Dictation Products
Service Bulletin

Model: M-2000

No. 10

Subject: "Play" Pedal Breaks

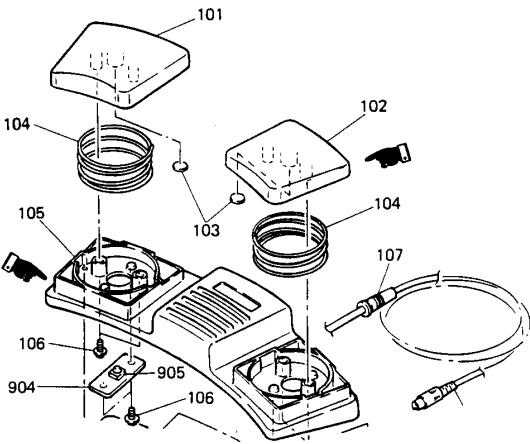
Symptom:
(63) The posts on the "play" pedal may break with heavy usage.

Solution: If the above symptom occurs, replace the pedal case along with the pedal. The improved case helps to prevent pedal breakage.
